## **ADDENDUM #4**

### **Rye City School District**

#### **Osborn Elementary School**

#### **Midland Elementary School**

SEAL & SIGNATURE DATE: 04/15/20  
PROJECT No: 9200  
DRAWING BY: Author  
CHK BY: Checker  
DWG No: A3-603

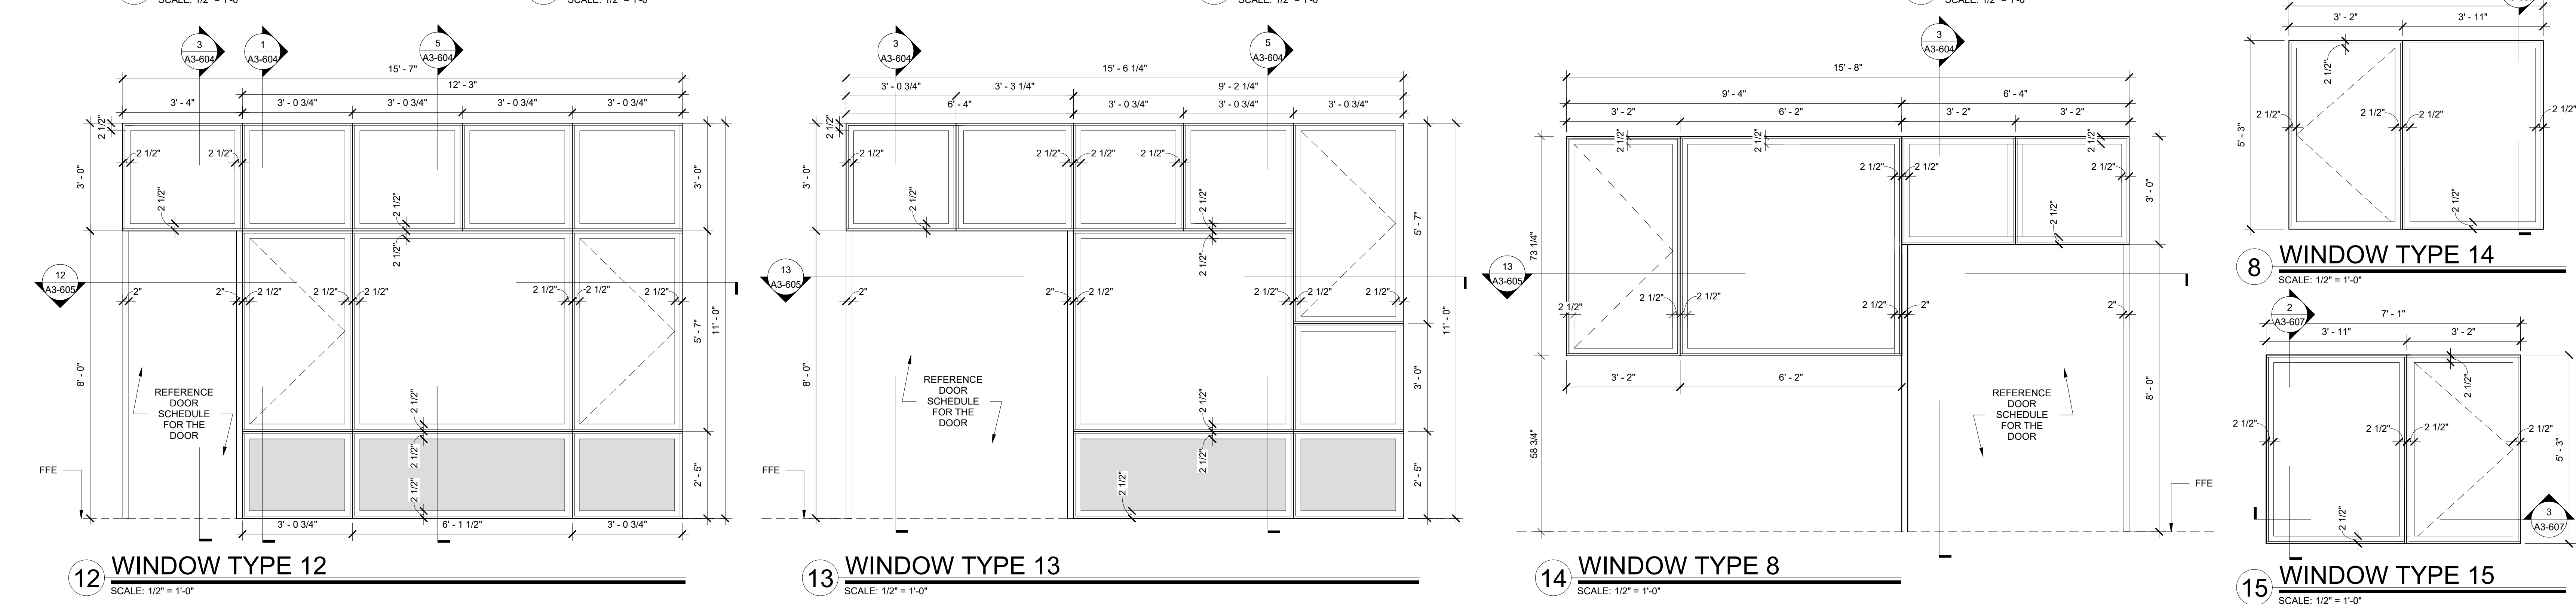
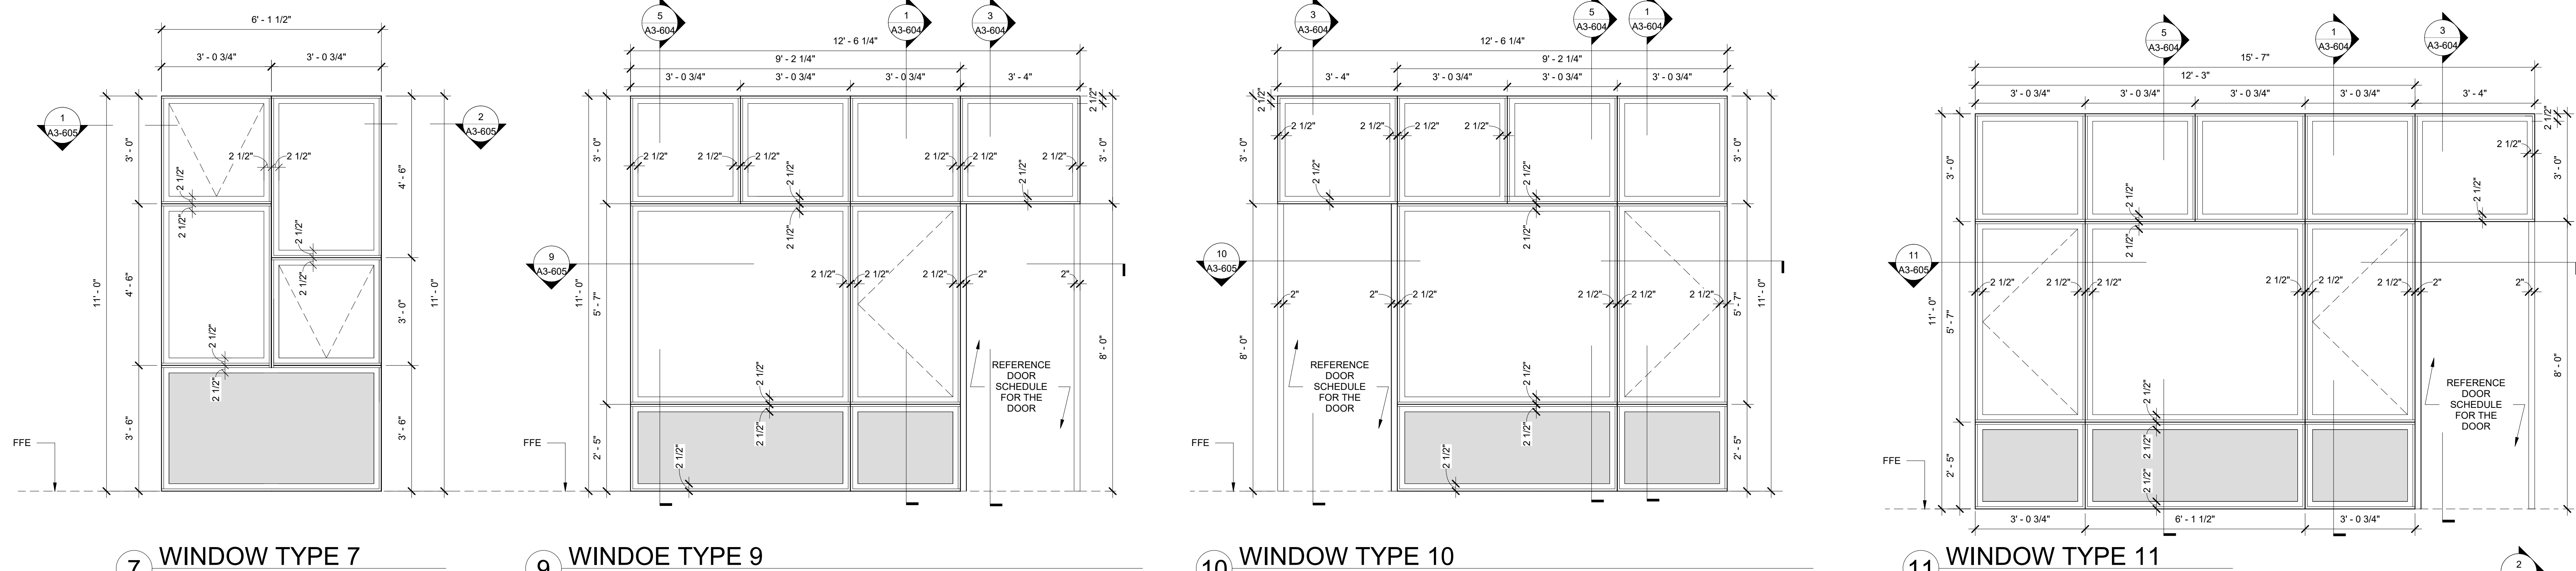
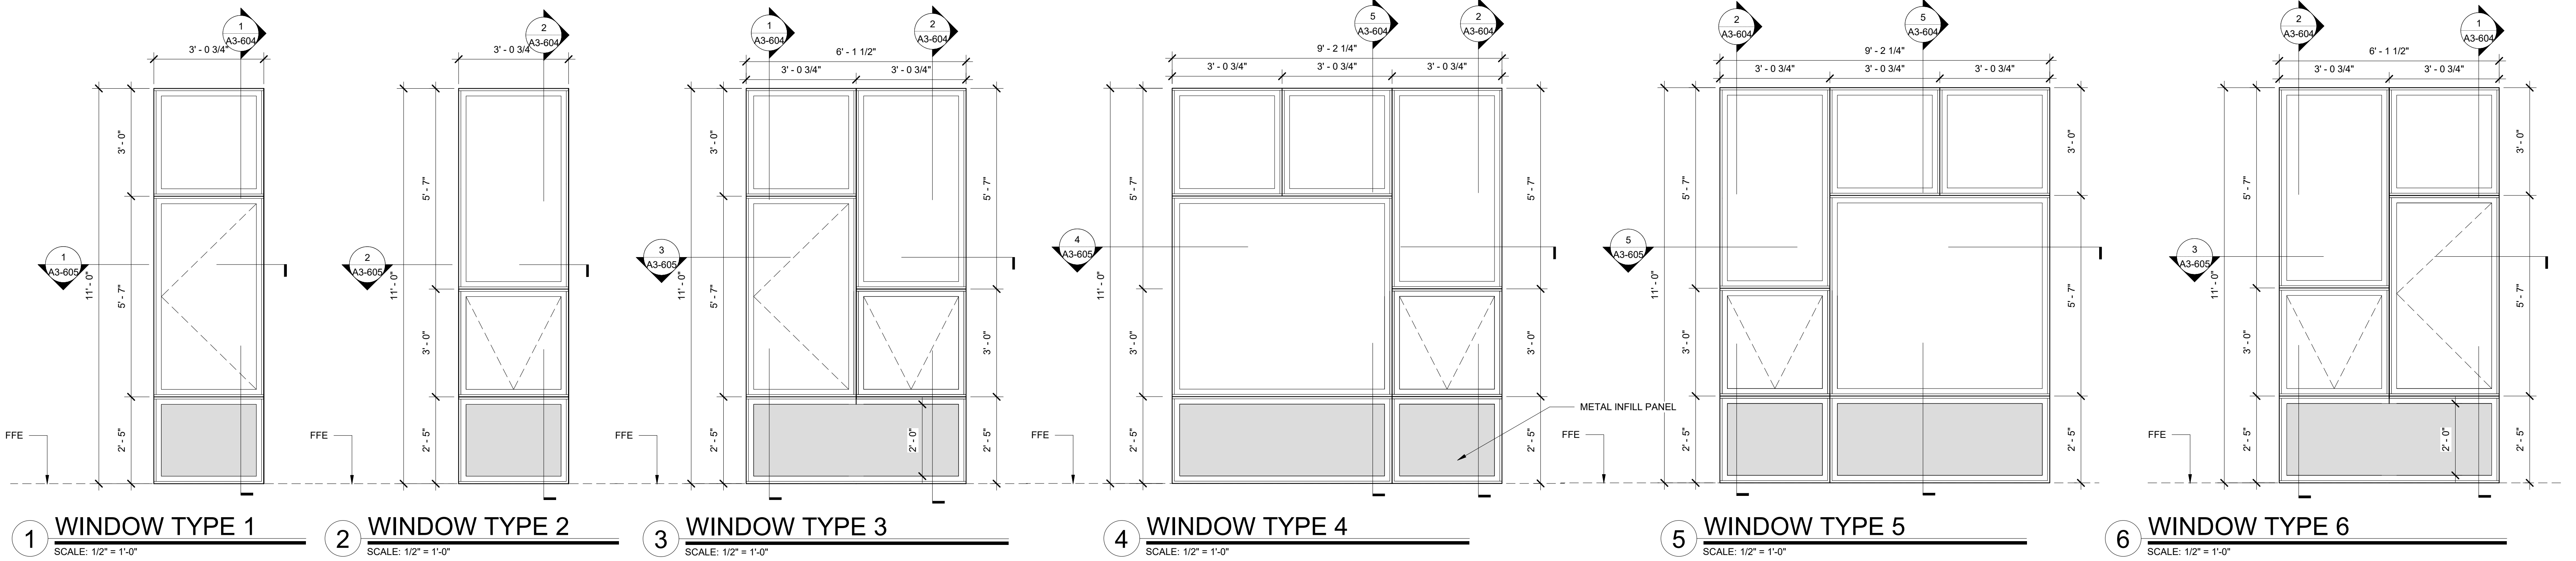
- a. Glazing type noted
5. A3-700 – FINISH SCHEDULE AND LEGEND
  - a. LVT-1 added to legend
6. A3-720 – ADDITION FLOORING PATTERN
  - a. Flooring for rooms 35 & 36 annotated

**Answer:** Door and window schedules updated to show glazing type per specifications.
7. **Question:** Please clarify which door tags spec section 088813 applies to. The

SEAL & SIGNATURE | DATE: 07/27/20  
PROJECT No: 9200  
DRAWING BY: Author  
CHK BY: Checker  
DWG No: A3-700

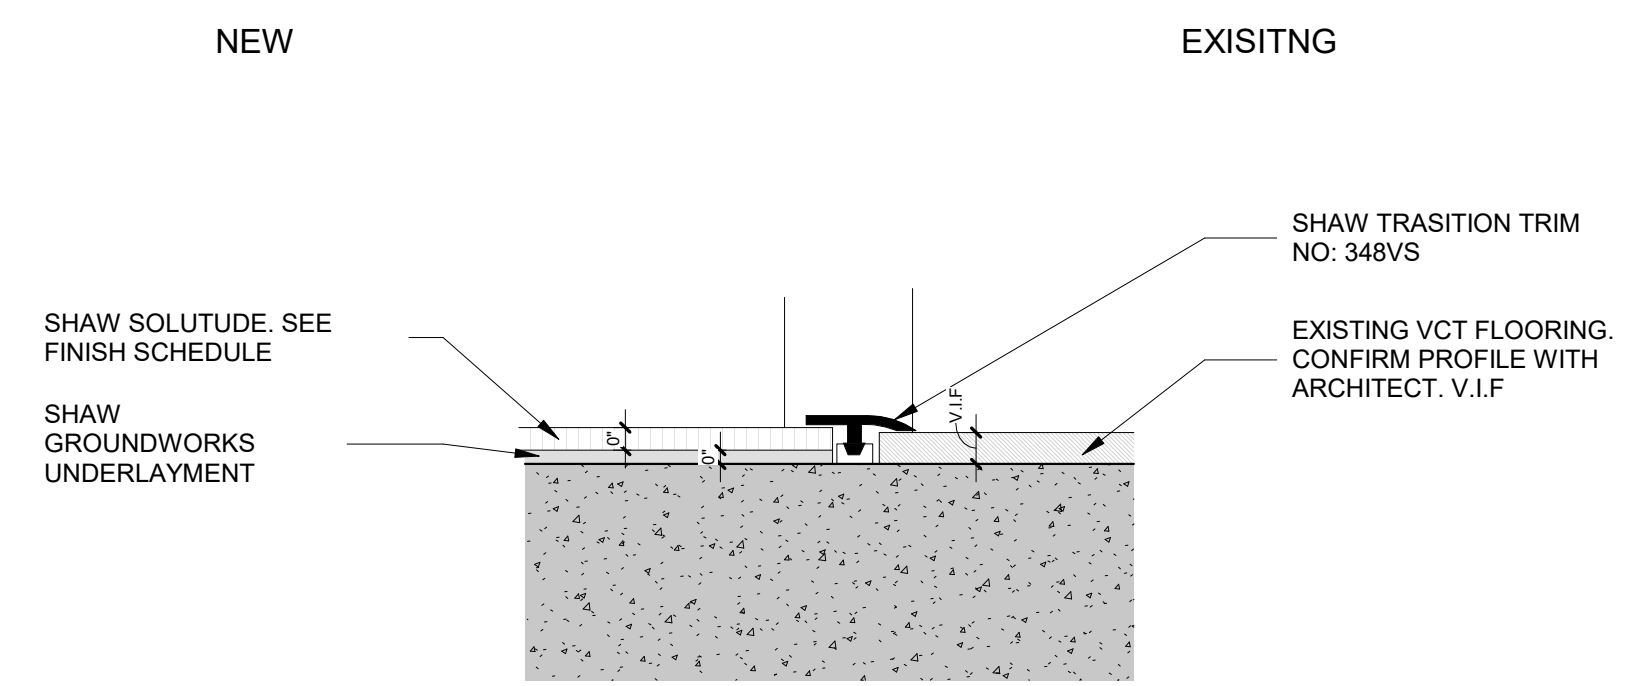
1. **Question:** The Finish Schedule for the Midland ES calls for LVT-1 in rooms 35 & 36 yet this material is not listed in the Finish legend. – please advise

**Answer:** Correct. LVT-1 is Shaw Solitude LVT; Color 48516 Fawn; 4100 adhesive. Updated finish legend provided in this addendum.
2. **Question:** The hardware sets on the door schedule do not line up with the spec documents. What door material is the intruder resistant glass doors? Please advise.
